CITY OF DALLAS LANDMARK COMMISSION

Monday, February 3, 2020

AGENDA

EAST ELEVATION

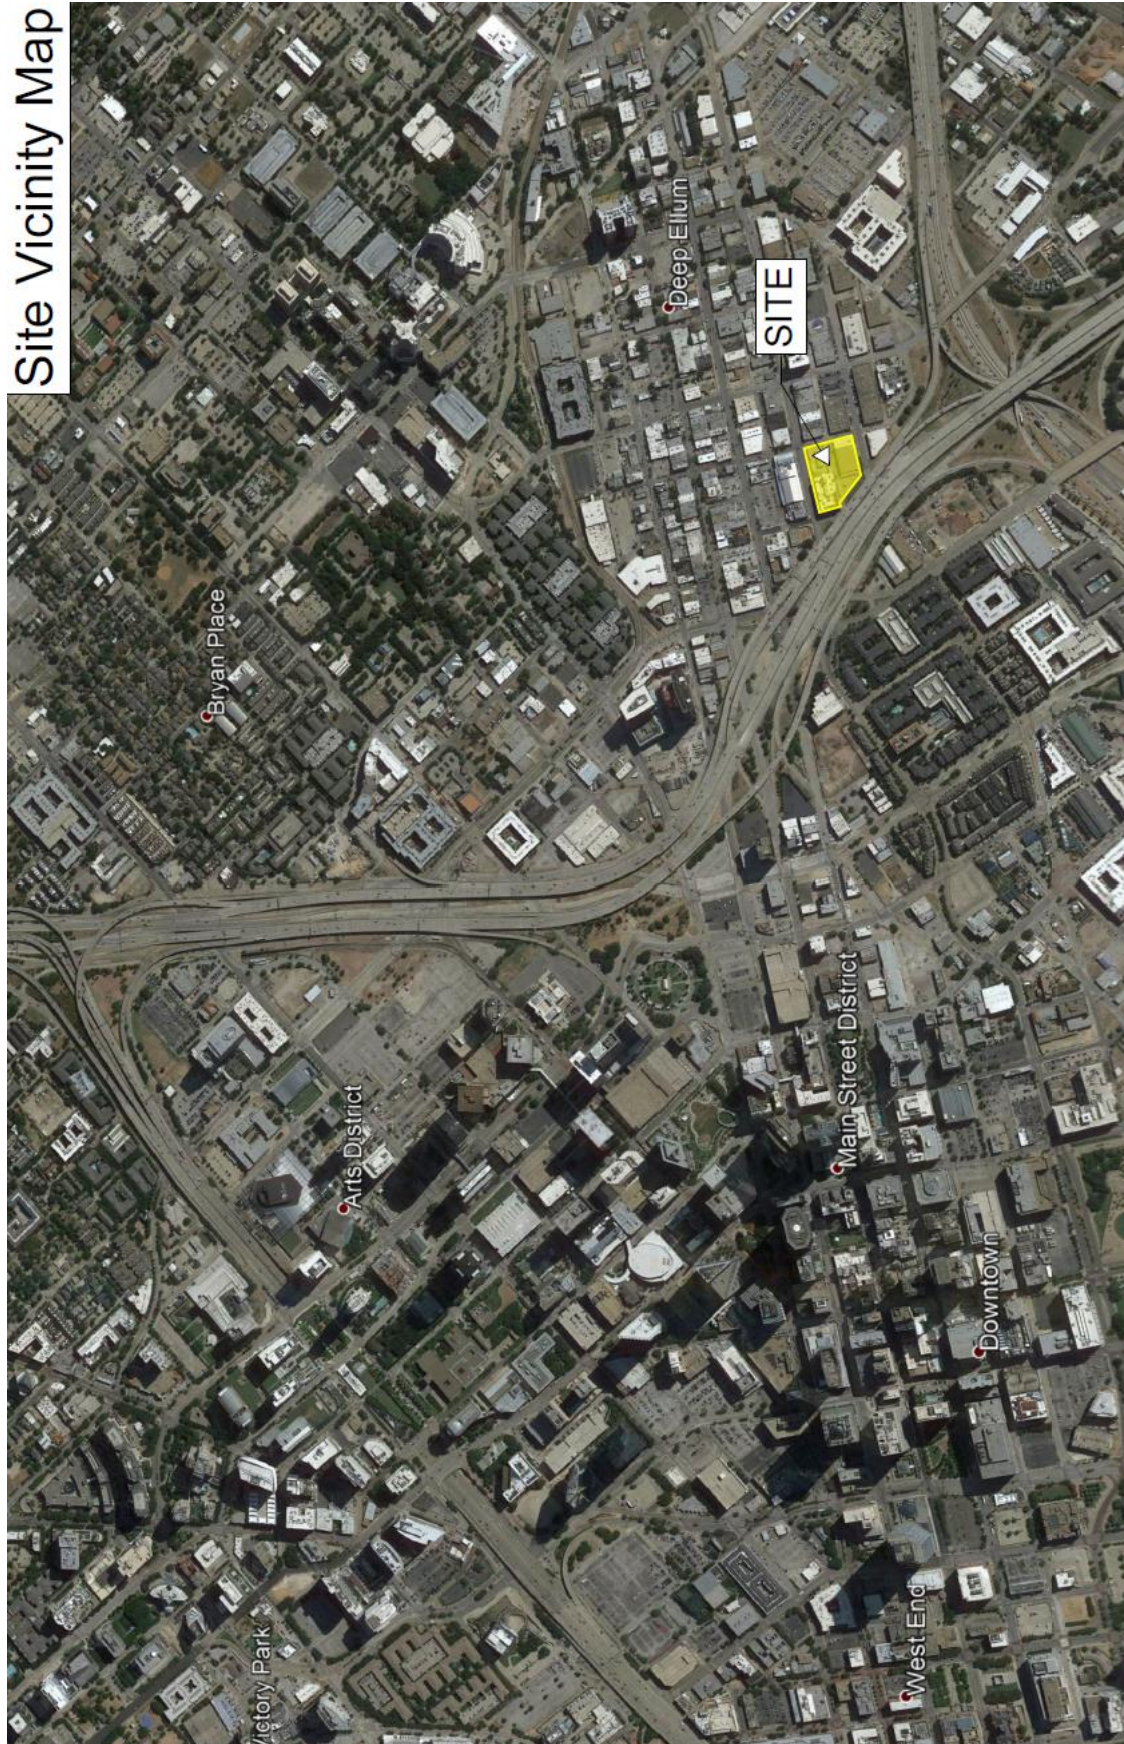
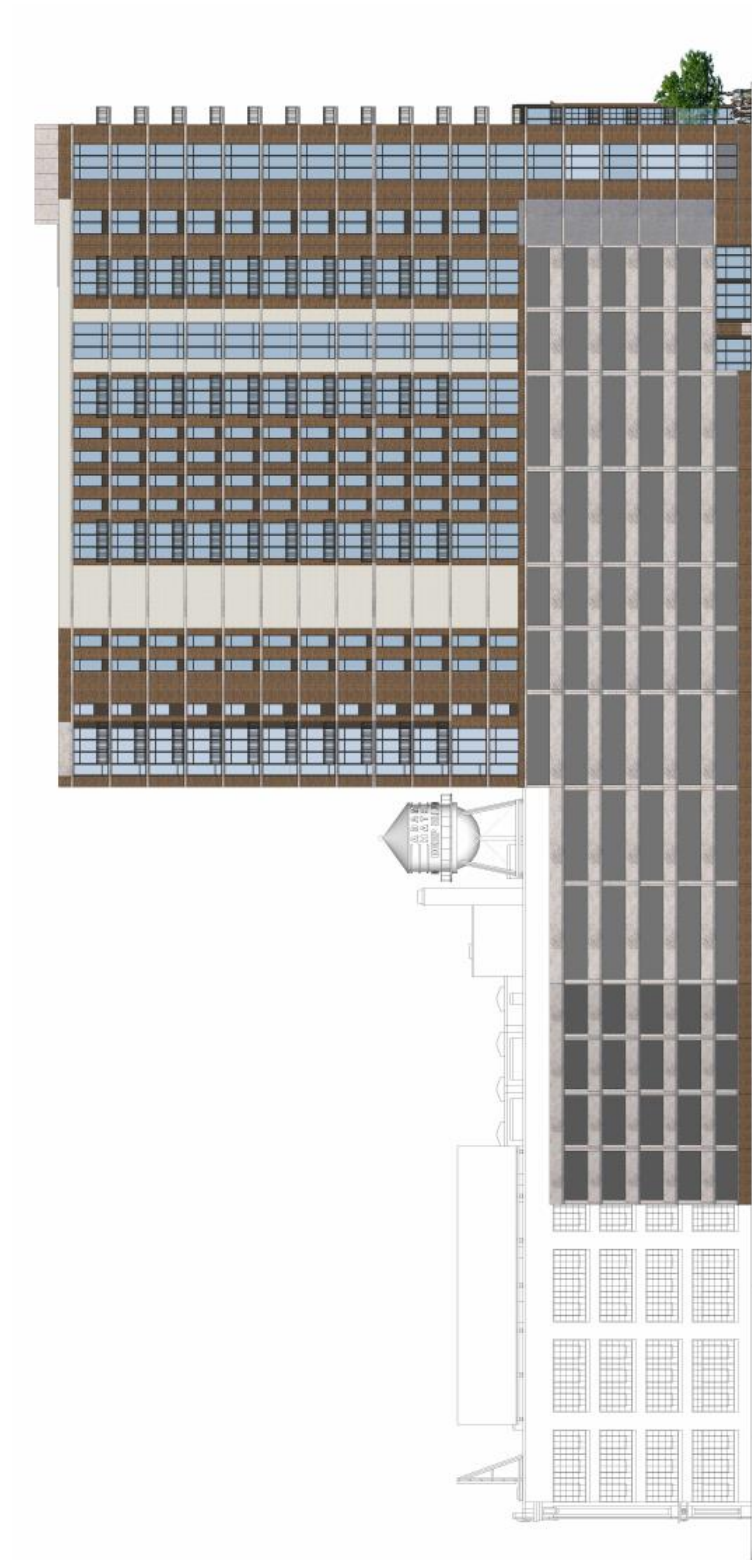
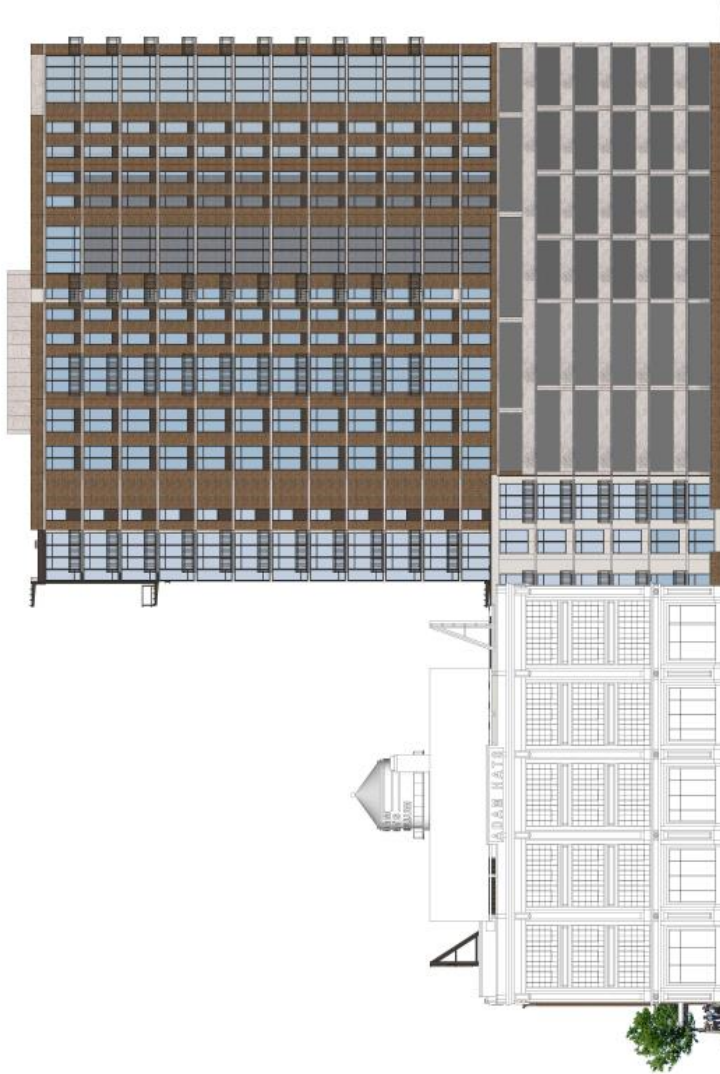
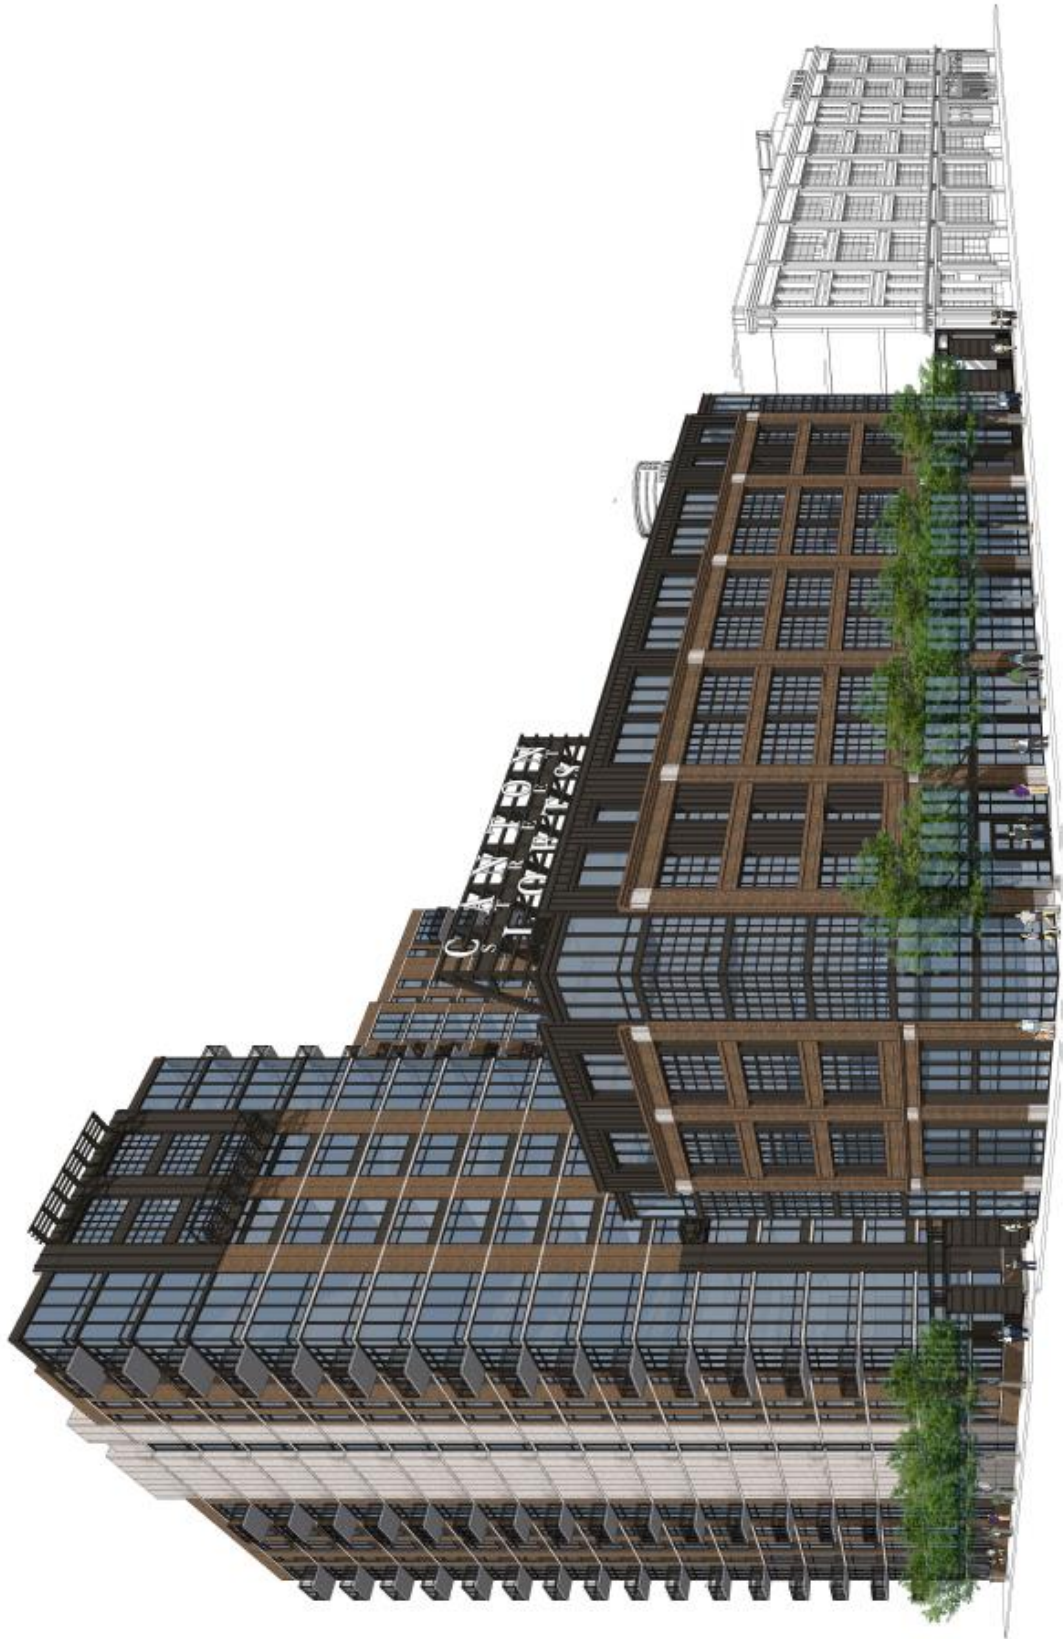
Courtesy Review – Construct a multi-story, multifamily building with parking garage. – No quorum – Provide detail for materiality and design of top floor; Garage height variance is acceptable on southwest corner of site; Security detailing needed for motor court gate; rooftop signage must meet Dallas Development Code signage requirements.

PROVIDE DETAIL FOR MATERIALITY AND DESIGN OF
TOP FLOOR, GARAGE HEIGHT VARIANCE IS ACCEPTABLE
ON SW CORNER

Courtesy Review – Construct a multi-story, multifamily building with parking garage. – Approve conceptually with the condition that final plans, elevations, and details are submitted for final Landmark Commission review.

Request #1 – Porch enclosure: Details

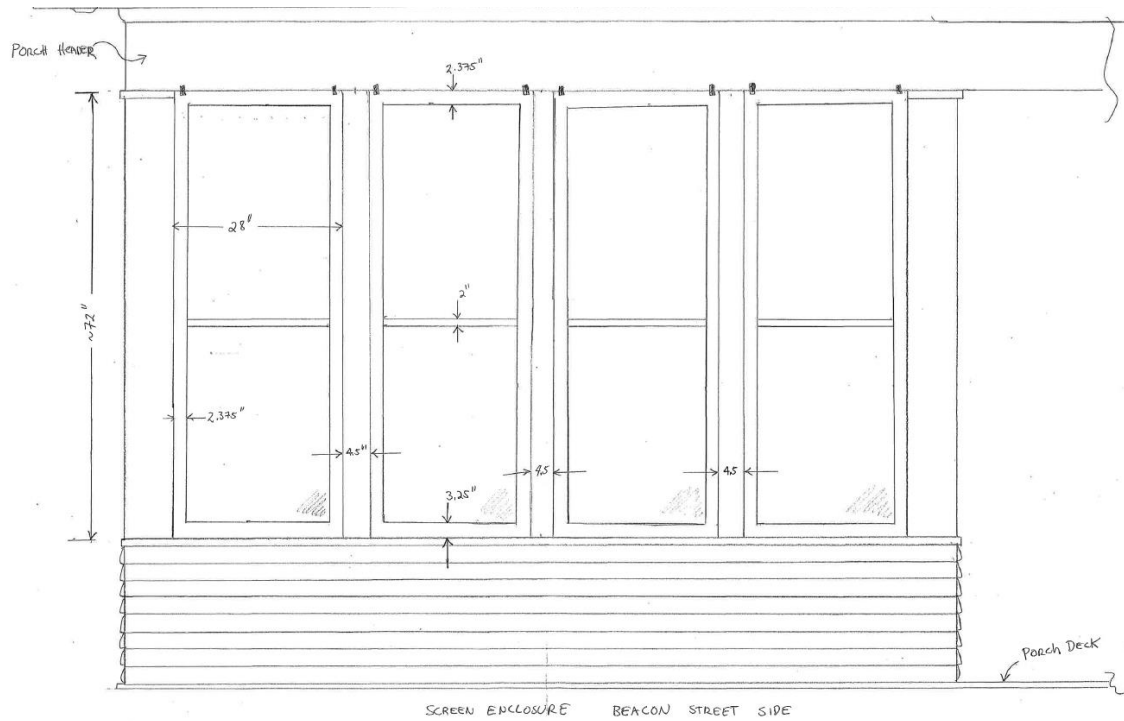
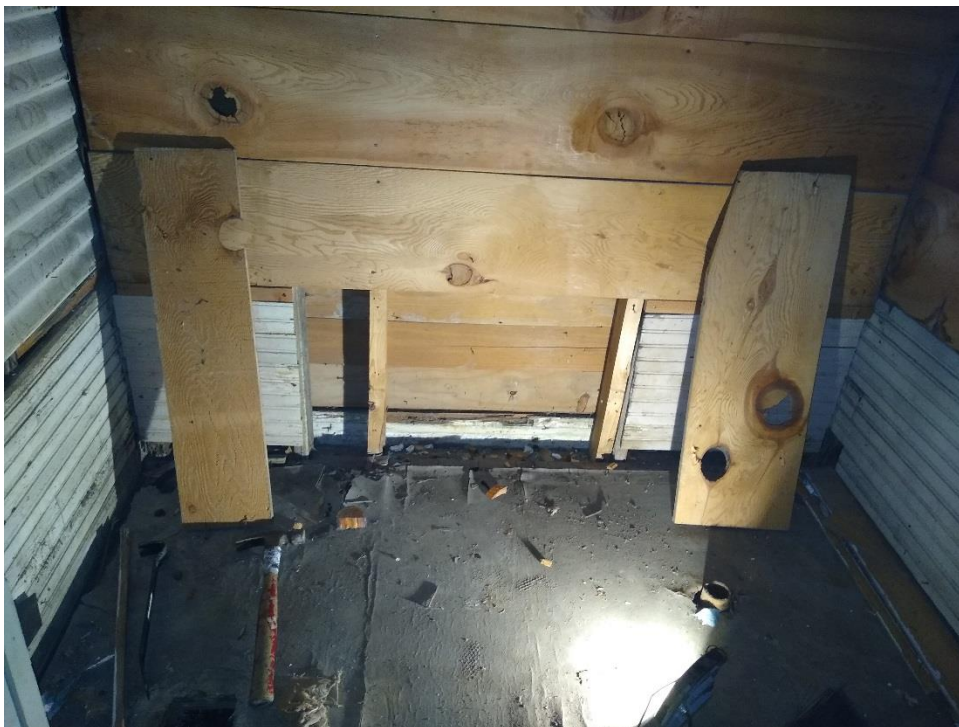
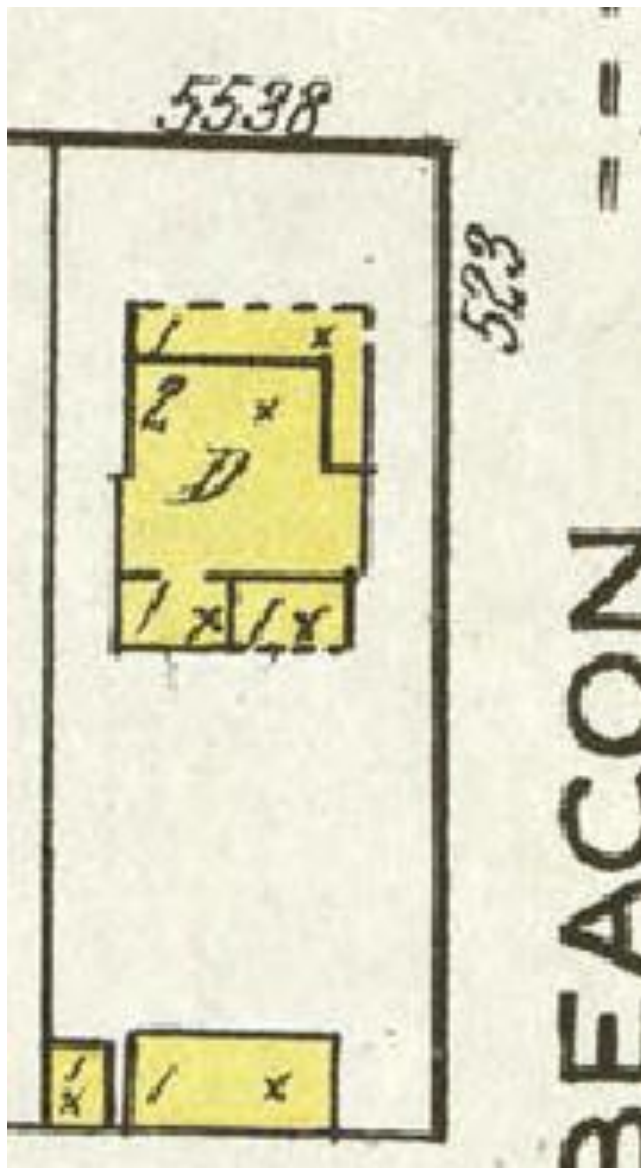
1. Remove existing porch enclosure and construct new screened-in porch on front elevation – Deny without Prejudice – Doesn't meet Section 7.2. Existing knee wall once was there and should be restored, but the enclosed portion was probably not original.
2. Widen steps on front porch – Approve.
3. Paint main structure. Brand: Valspar. Body: 4004-10A "Sassy Violet;" Trim: "White;" Accent: "Grey;" Porch floor: "Red" – Approve – Approve as shown since it does not violate Section 4.8.
4. Install 6' wood fence in side and rear yard – Approve.
5. Install 5' gate in southwest side yard – Approve – Approve.

1. Remove existing porch enclosure and construct new screened-in porch on front elevation – Deny without Prejudice – The proposed work does not meet the standards in City Code Section 51A-4.501(g)(6)(C)(i) because it is not consistent with preservation criteria Section 7.2 states that porches and balconies on protected facades may not be enclosed, and that it is recommended that existing enclosed porches on protected facades be restored to their historic appearance.

Request #1 – Window survey.

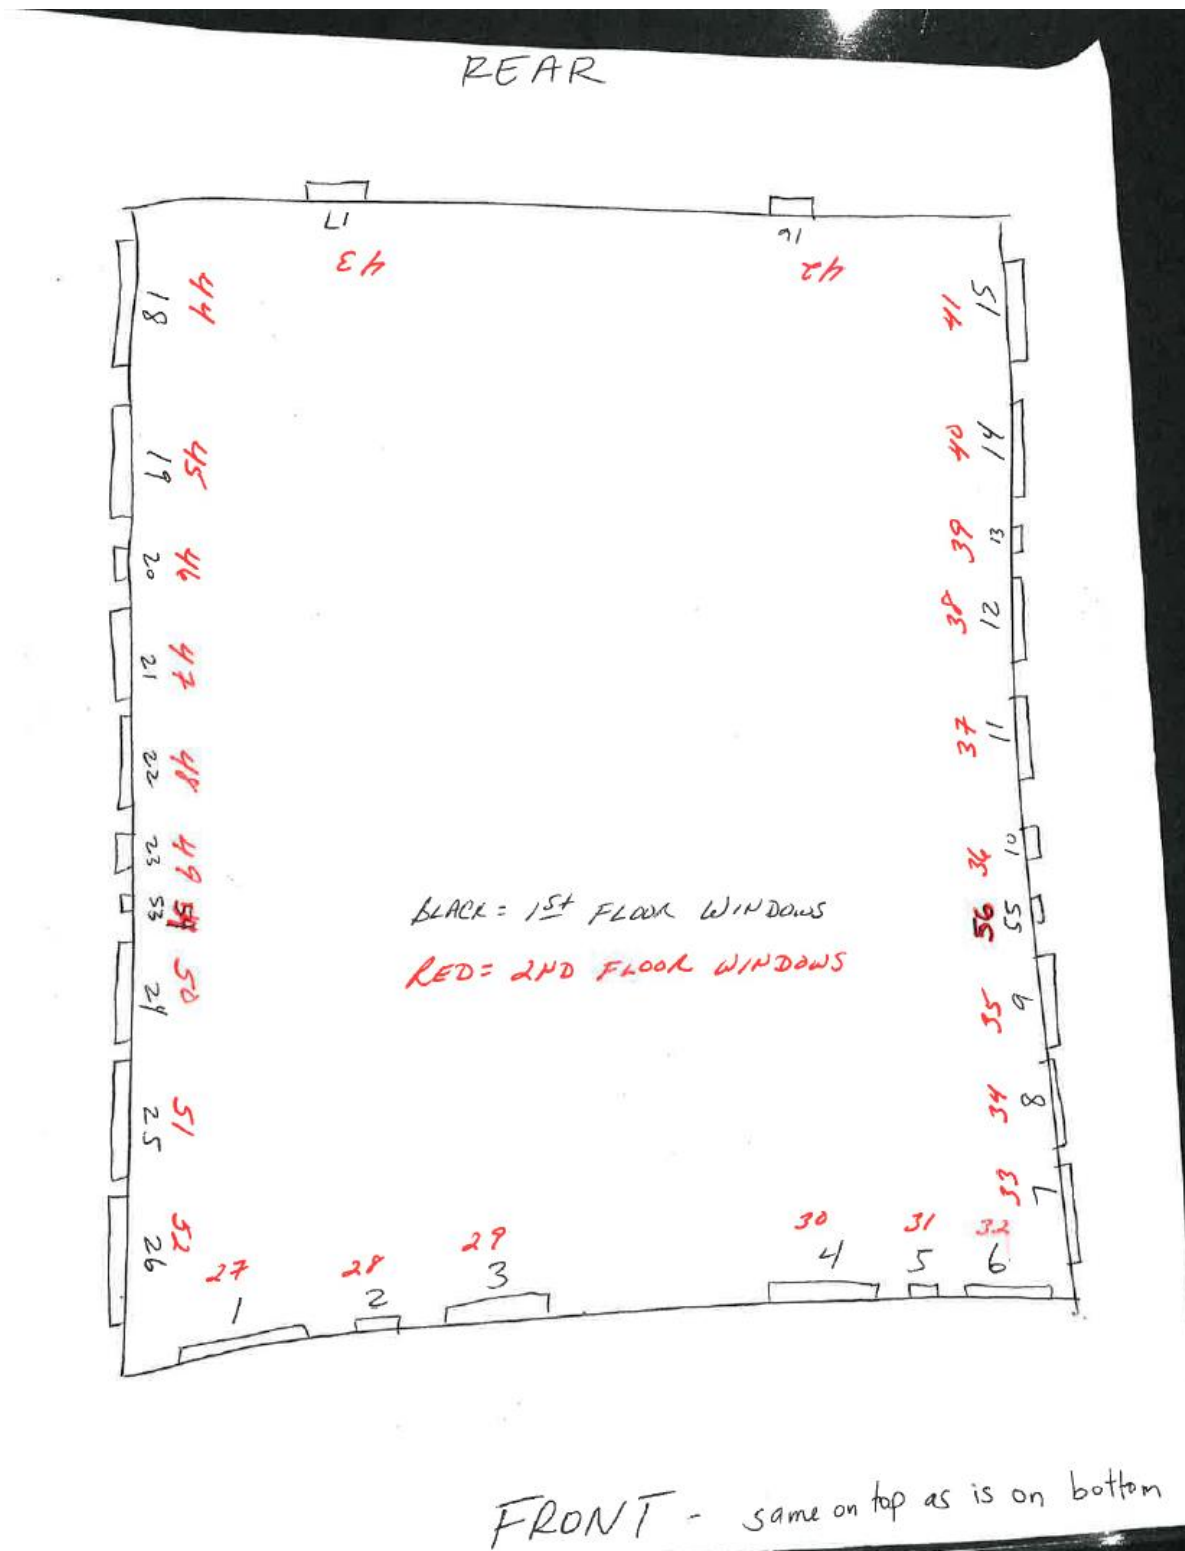
- 1) Replace all windows with new aluminum windows – Approve – Approval of aluminum windows as they were existing prior to the fire and were probably original.
- 2) Paint brick structure. Brand: Sherwin Williams. Custom match – 7005 Pure White, A-100 – Deny without prejudice – Cleaning fire damage and graffiti must be explored thoroughly. Contact city staff and Preservation Dallas to get appropriate products to clean bricks. Brick is original and has historic and aesthetic value.

- 1) Replace all windows with new aluminum windows – Approve with conditions – Approve window survey dated 2/3/2020 with the conditions that the aluminum replacement windows use the adobe grey finish color, must fit the original window openings, and that each window is replaced with one that matches the style, size, number of glass panes, configuration, dimensions, and profile of the existing with the finding the work meets the standard in City Code Section 51A-4.501(g)(6)(C)(ii).
- 2) Paint brick structure. Brand: Sherwin Williams. Custom match – 7005 Pure White, A-100 – Deny without prejudice – The proposed work does not meet the standard in City Code Section 51A-4.501(g)(6)(C)(ii) because painting brick would have an adverse effect on the historic overlay district.
